Staff Report

File #: 19-333

City Council review of the Planning Administrator's decision approving a Tentative Subdivision Review with a Class 1 Adjustment application for Permit Case No. SUB-ADJ19-02 for property located in the 500 to 600 Block of Salem Heights Avenue S.

WREN HEIGHTS SUBDIVISION

ALTERNATIVE #2
ALT COLLECTOR PLAN VIEW

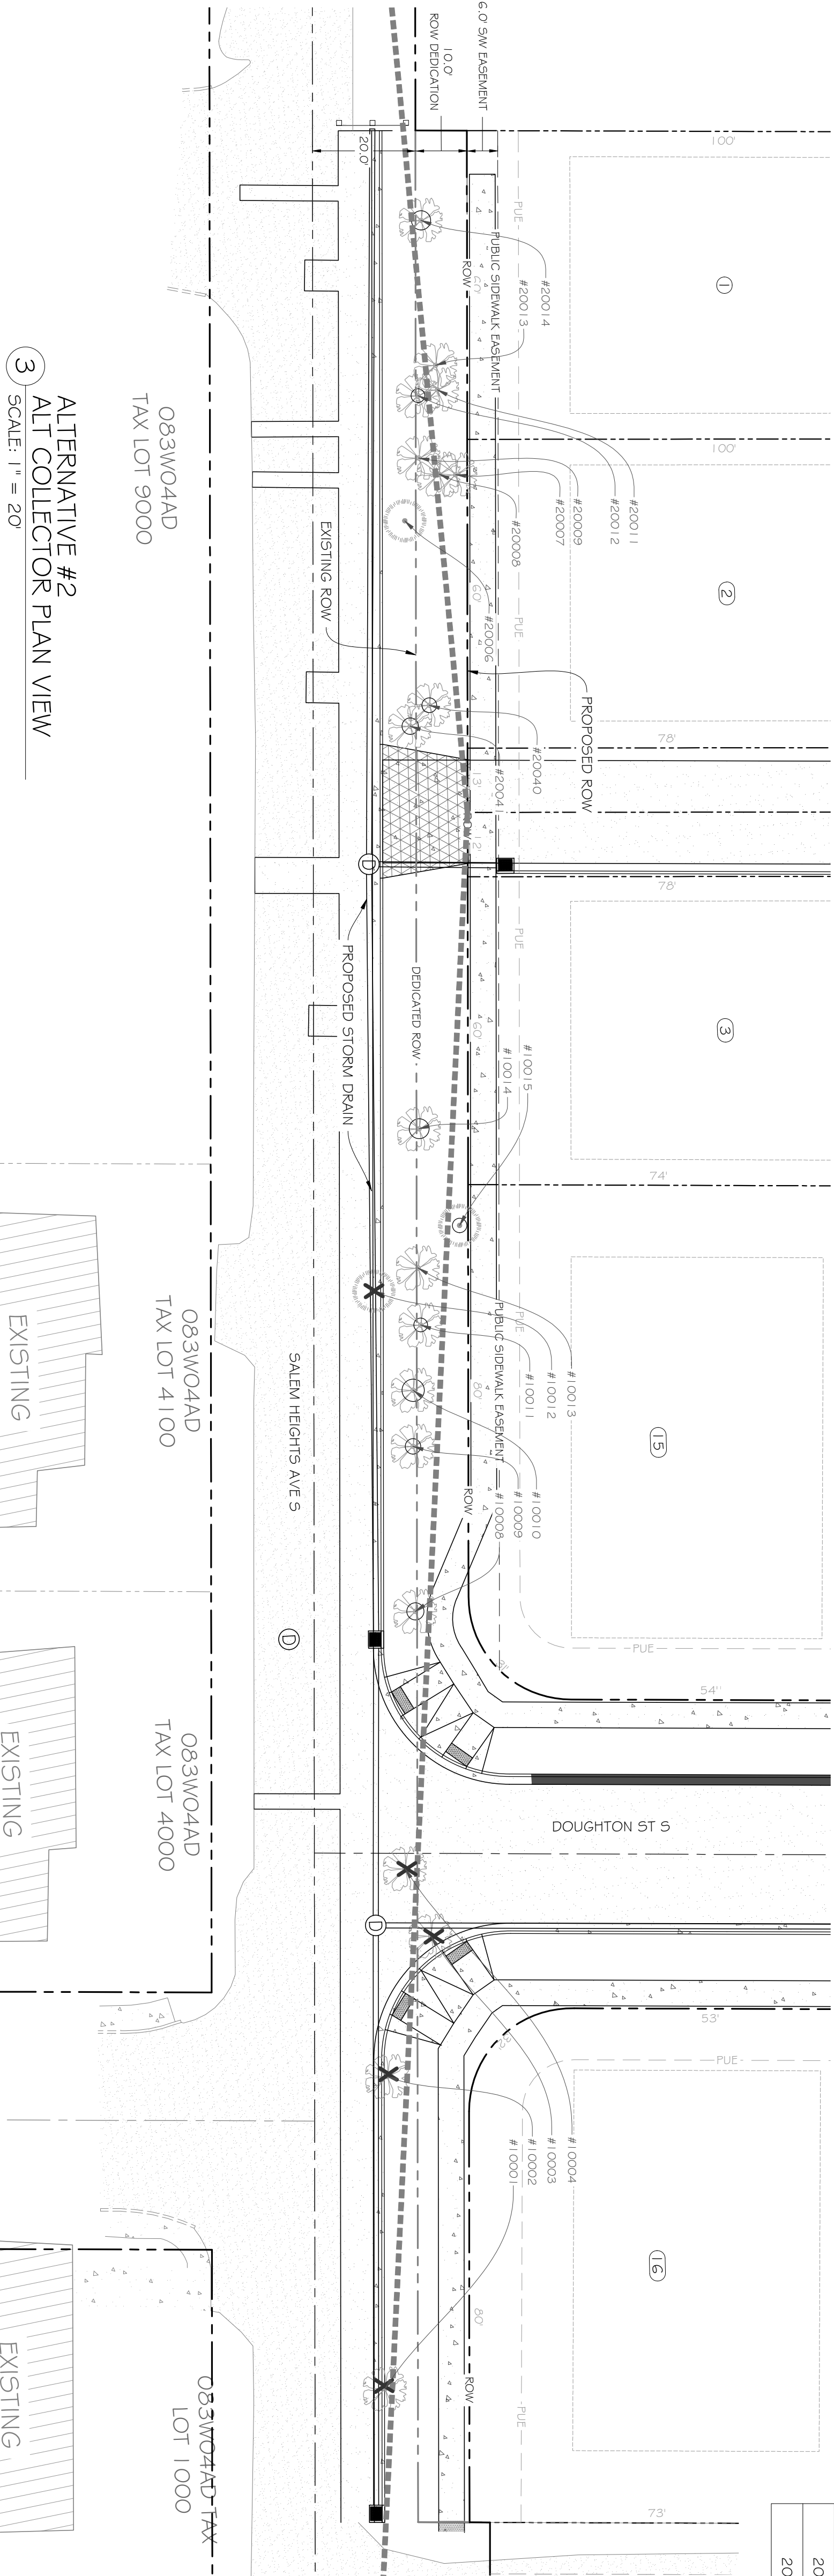
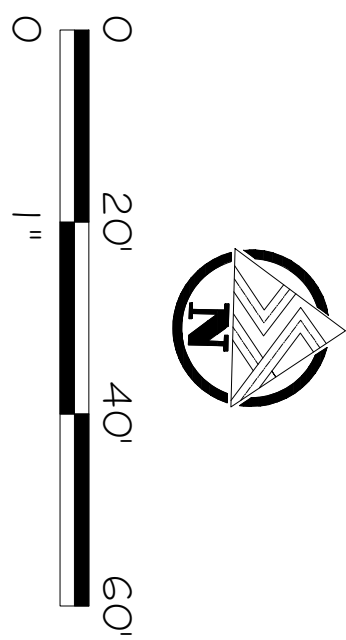
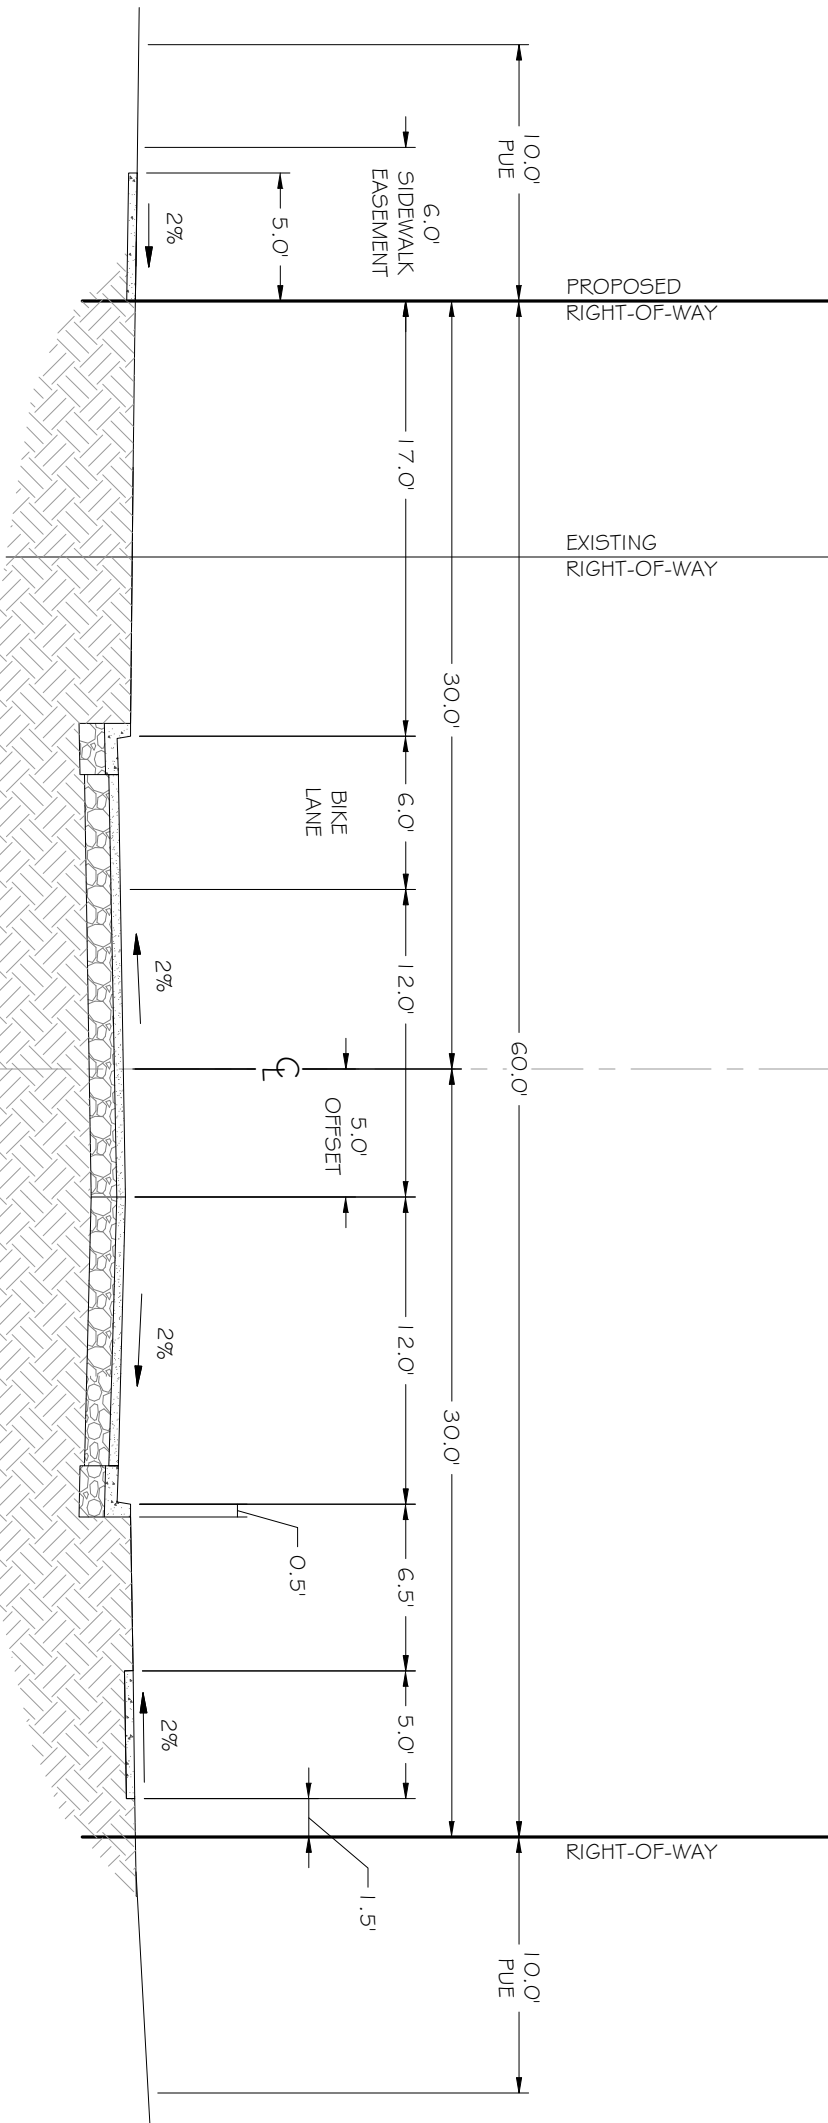
- Condition 8:** Prior to issuance of public construction permits, obtain final approval for tree removal permits for trees labeled as 10001 – 10004, and 10012 identified in the plan submitted on May 7, 2019 and titled Tree s within Right-of-Way Conservation Plan (Attachment C). Trees labeled as 10001 – 10004, and 10012 are tentatively approved for removal.

- Condition 9:** Prior to issuance of public construction permits, a tree preservation and protection plan pursuant to SRC Chapter 86 and Salem Administrative Rule 109-500, and signed by a certified arborist, shall be submitted for the identified preserved "Future Street Trees" (trees labeled as 20006- 20009, 20011- 2014, 20040, 20041, 10008 - 10011, 10013 – 10015, show on Attachment C), to the City for review. Future Street Trees, identified above, shall be preserved. Any proposed removal of identified Future Street Trees (listed above) would require a separate removal permit pursuant to SRC 86.090.

ALTERNATIVE #2
ALT COLLECTOR PLAN VIEW

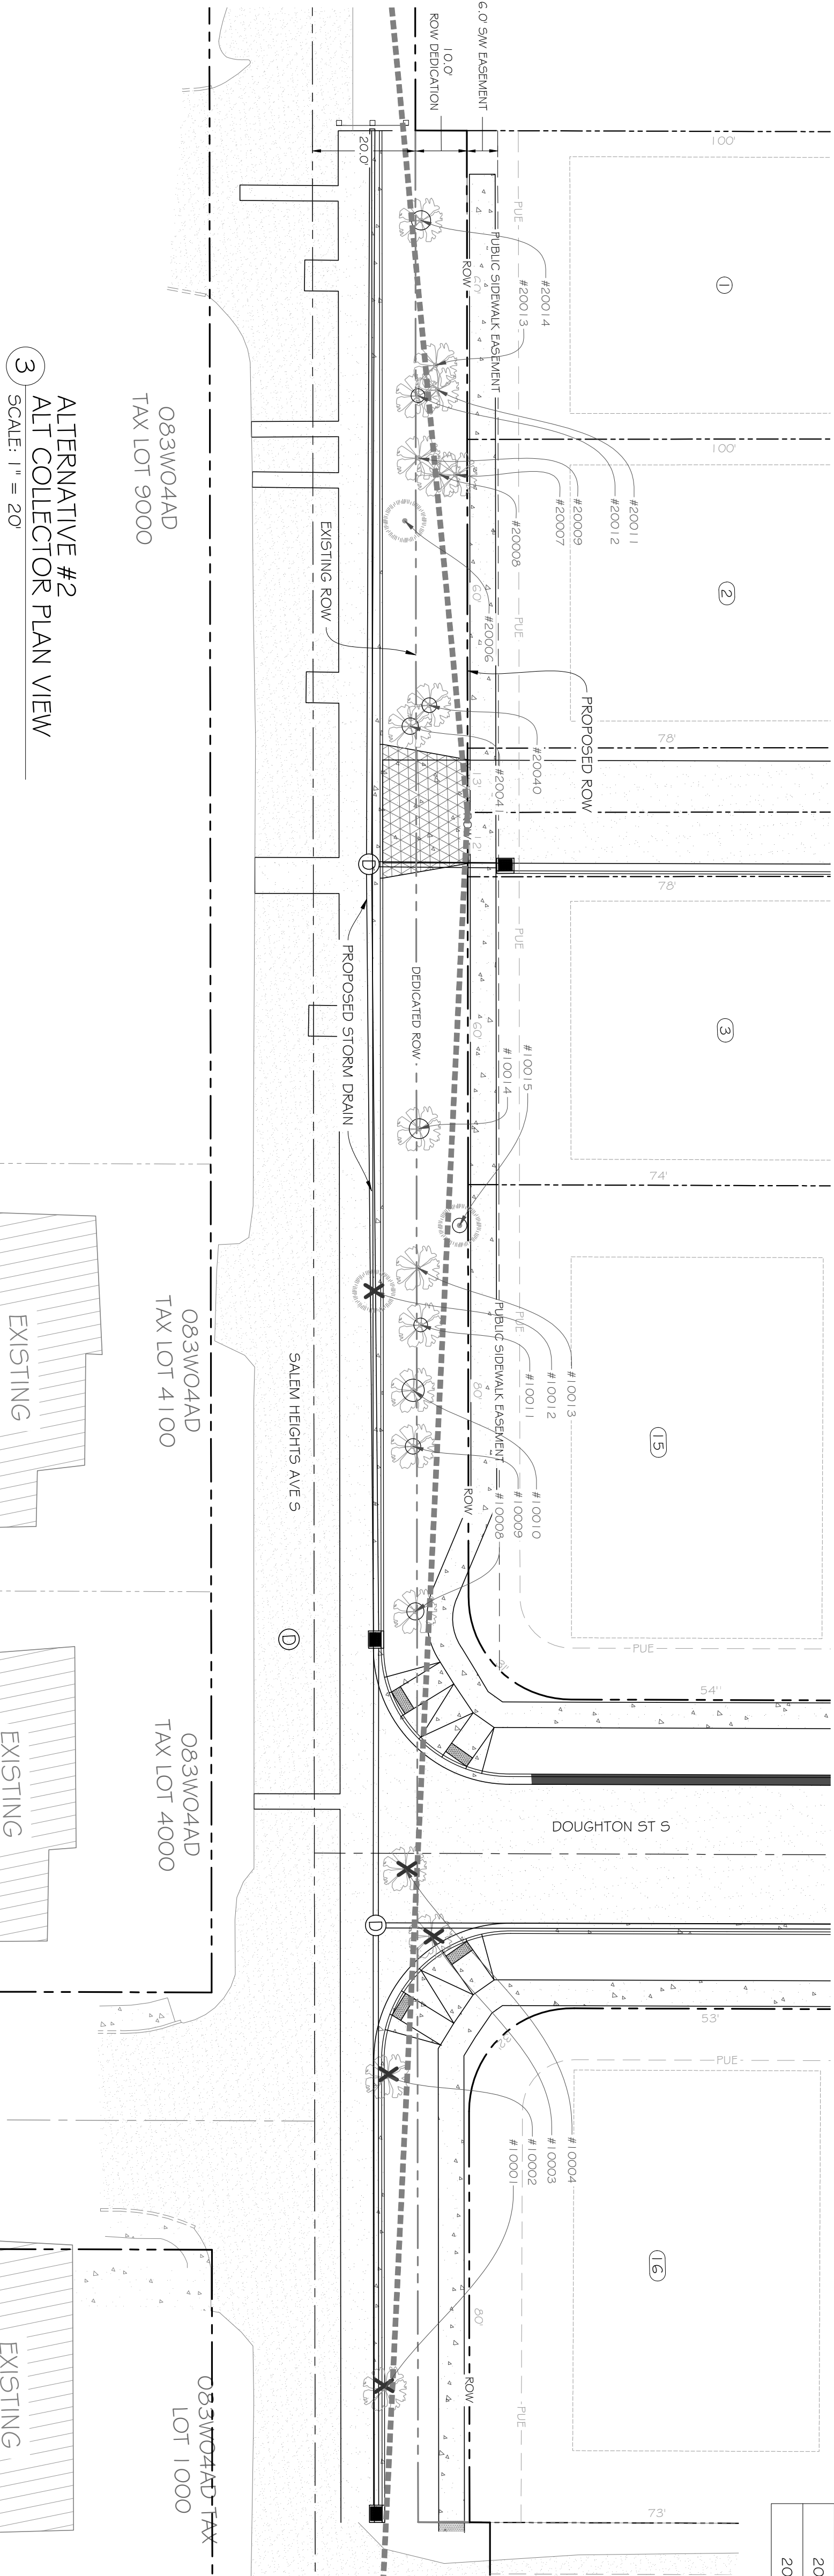
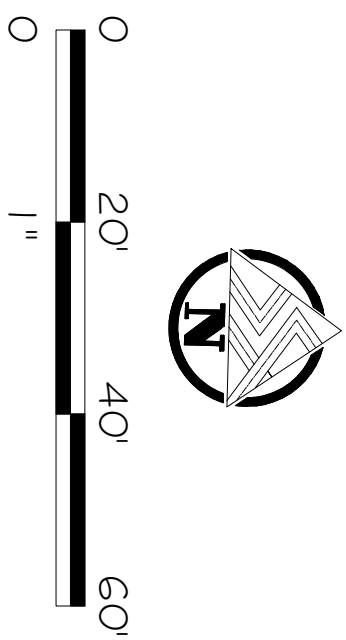
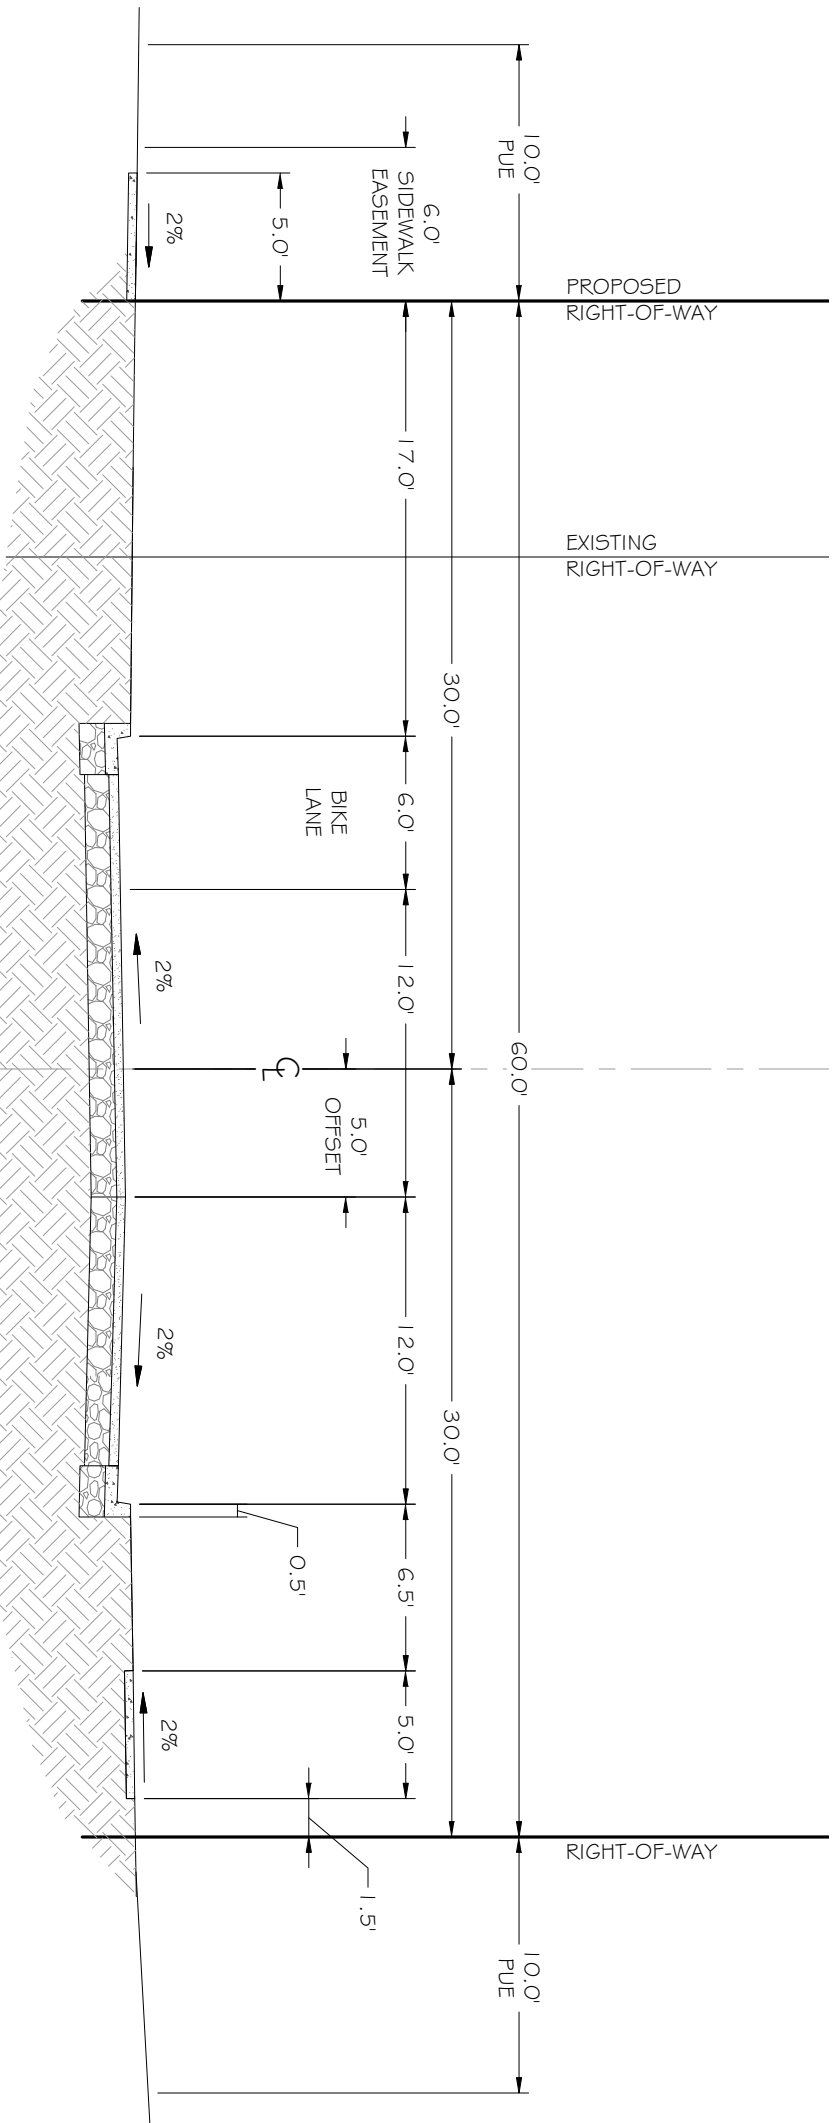
2. Prior to issuance of Public Construction permits, obtain tree removal permits for trees located within the right-of-way along the frontage of Salem Heights Avenue S. In accordance with the plan submitted on May 7, 2019 and titled Trees Within Right-of-Way Conservation Plan (C-1.17), trees labeled as 10001 – 10004, and 10012 are tentatively approved for removal. Any additional removal of street trees requires

3. Prior to issuance of Public Construction permits, a tree preservation and protection plan pursuant to SRC Chapter 86 and Salem Administrative Rule 109-500, and signed by a certified arborist, shall be submitted to the City for review and approval. In accordance with the plan submitted on May 7, 2019 and titled Trees Within Right-of-Way Conservation Plan (C-1.17), trees labeled as 10008 - 10011, 10013 – 10015, 20006- 20009, 20011- 20014, 20040, and 20041 are slated for preservation.

future street trees. In accordance with the plan submitted on May 7, 2019 and titled Trees Within Right-of-Way Conservation Plan (C-1.17), trees labeled as 10001 – 10004, and 10012 are tentatively approved for removal. The applicant shall obtain tree removal permits pursuant to SRC Chapter 86 prior to issuance of Public Construction permits for the street improvement of Salem Heights Avenue S. Any additional removal of street trees requires approval pursuant to SRC 86.090. For all remaining trees (10008 - 10011, 10013 – 10015, 20006- 20009, 20011- 20014, 20040, and 20041), a tree preservation and protection plan pursuant to SRC Chapter 86 and Salem Administrative Rule 109-500, and signed by a certified arborist, shall be submitted to the City for review and approval prior to the issuance of Public Construction permits.
